**REGULAR MEETING OF THE
CITY OF CONCORD
DESIGN REVIEW BOARD**

**Thursday, September 22, 2016
5:30 p.m., Regular Meeting
PERMIT CENTER CONFERENCE ROOM
1950 Parkside Drive, Bldg. D**

- 1. **Argent Concord (PL16333 – DR) – Preliminary Design Review for a 171-unit apartment project on a 1.6-acre site at 2400 Willow Pass Road. The General Plan designation is Downtown Mixed Use; Zoning classification is DMX (Downtown Mixed Use); APN 126-082-008. Project Planner: Afshan Hamid @ (925) 671-3281**
- 2. **Sprouts Farmers Market (PRE16004) – Conceptual Design Review to construct an approximately 30,000 sq. ft. Sprouts Market on a 2.65-acre site located at 4475 Treat Boulevard. The General Plan designation is Commercial Mixed Use; Zoning classification is CMX (Commercial Mixed Use); APN 132-160-010. Project Planner: Frank Abejo @ (925) 671-3128**

Subject: Response to DRB Comments – PL16202-DR

9 ROOF SCREEN - ELEVATION

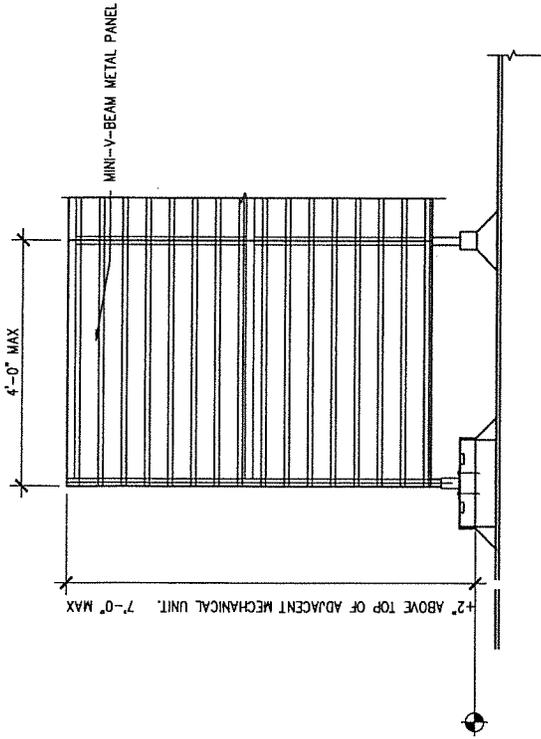
Response: Specification for "powder coated black" security screen added to Sheet A-5.2.

CONCEPTUAL BUILDING PLAN - LEVEL 1

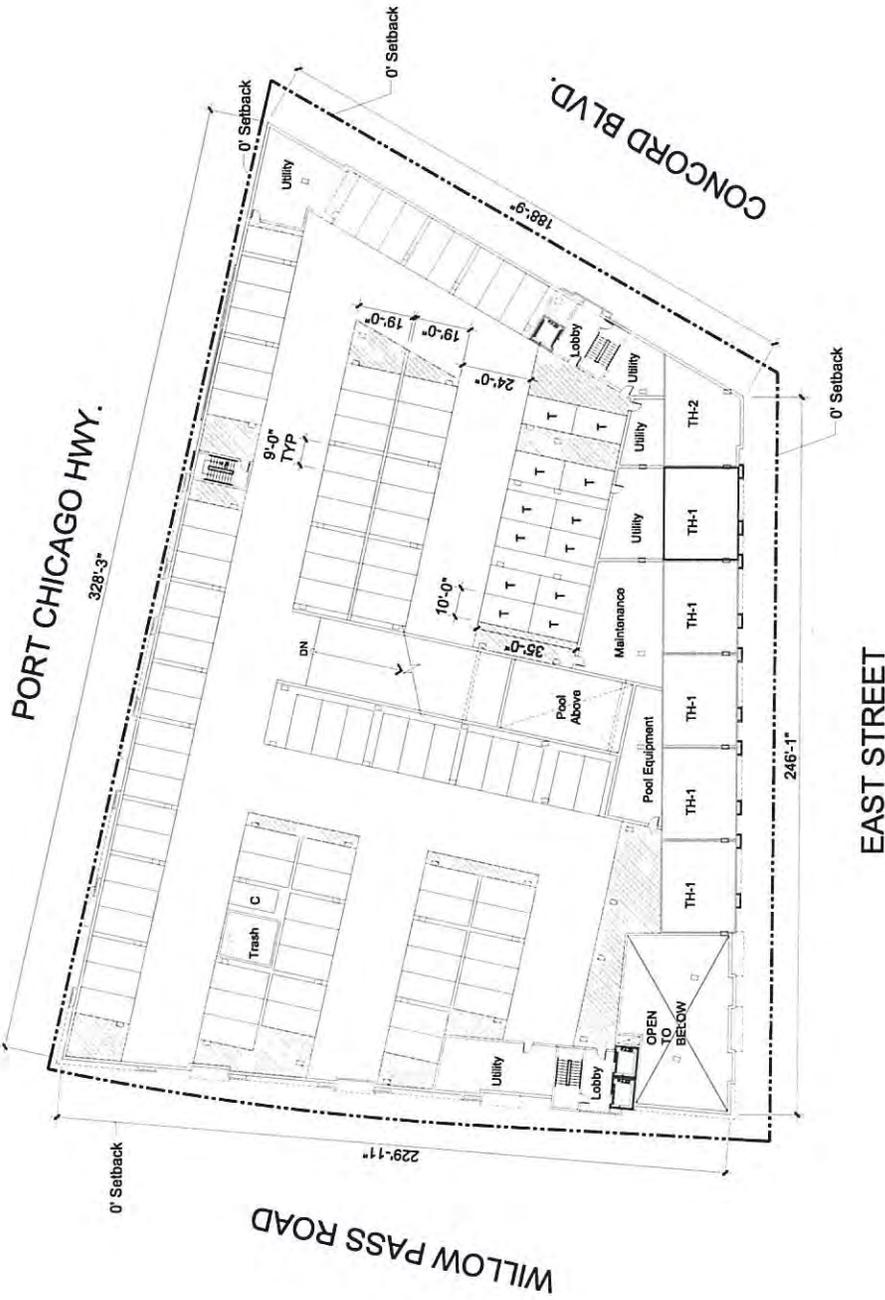
1. *The Board questioned the vehicular entrance off Willow Pass Road and if Port Chicago Hwy would be a better alternative.*

- The applicant shall locate the loading zone out of the public right-of-way.
- The applicant shall verify the required number of bicycle parking as recommended in the Bicycle, Pedestrian & Safe Routes to Transit Plan.
- The applicant shall provide the required number of motorcycle parking.

The project access has been revised with one vehicular access off Port Chicago Highway.

The applicant has revised the site plan with one vehicular access off Port Chicago Highway, which is supported by the Planning, Engineering and Transportation Divisions. East Street will serve as the primary elevation with townhome units. The applicant is proposing a loading zone off Concord Boulevard.

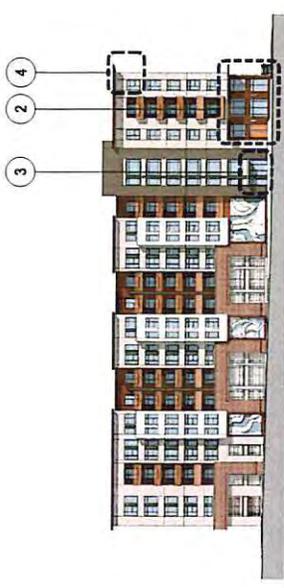
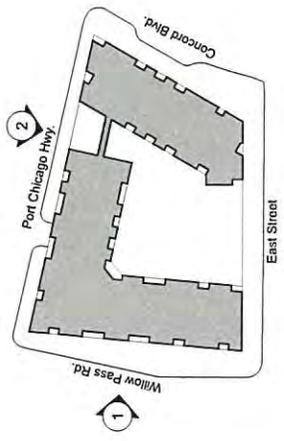
- It is recommended that on Sheet A6.1 detail 2, entry at leasing, and detail 3 storefront at leasing, provide an 18 to 24 inch setback at the storefront windows.
 - It is recommended that on Sheet A6.0 and A6.1, evaluate heavier vertical and horizontal mullions at the storefronts.
 - Provide a profile of the coping at the roof and identify the coping material for the building on Concord Boulevard. The coping should be substantial in detail for the scale and proportion of the project.
3. *The Board would like to see special details of how materials come together and interface at windows, reveals, balconies, recesses, and special areas such as entrances, typical units, roof and cornice, trim returns, joinery of materials.*

- It is recommended that on Sheet A6.0 and A6.1, evaluate heavier vertical and horizontal mullions at the storefronts.
- Provide a profile of the coping at the roof and identify the coping material for the building on Concord Boulevard. The coping should be substantial in detail for the scale and proportion of the project.

STREET LEVEL PLAN

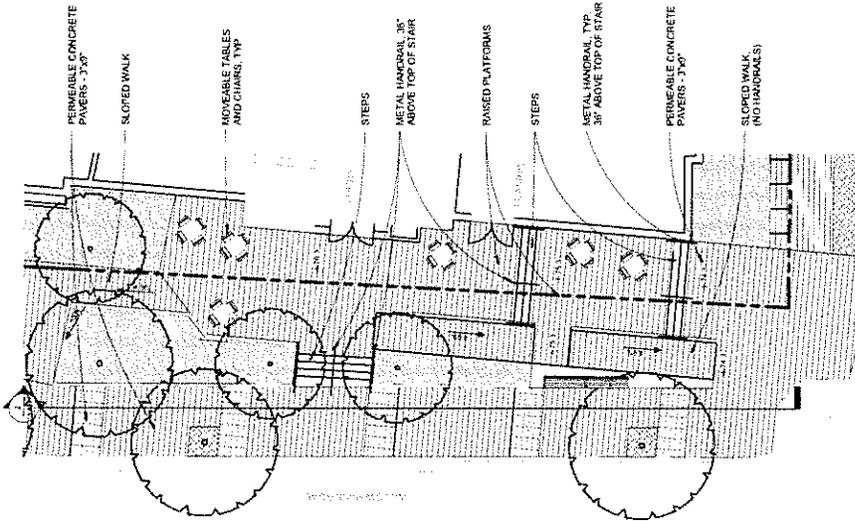
- Staff is recommending that the benches at street level include 3 arms to discourage loitering.
7. *Landscaping plan needs to be more comprehensive, with plant sizes, species, list, pot sizes and specifications, screen wall specifications in plan, detail and elevation, as well as irrigation plan.*

- Staff would like to see a more developed plant design with locations and layouts of the landscaping for Final Design Review. The palette should be native Californian and drought tolerant plant material. Tree sizes also need to comply with the Concord Development Code.
- Provide blow-ups of key planting, landscaping and paving areas.
- Evaluate the proposed tree locations that are on the existing utilities, storm drain lines and easements.
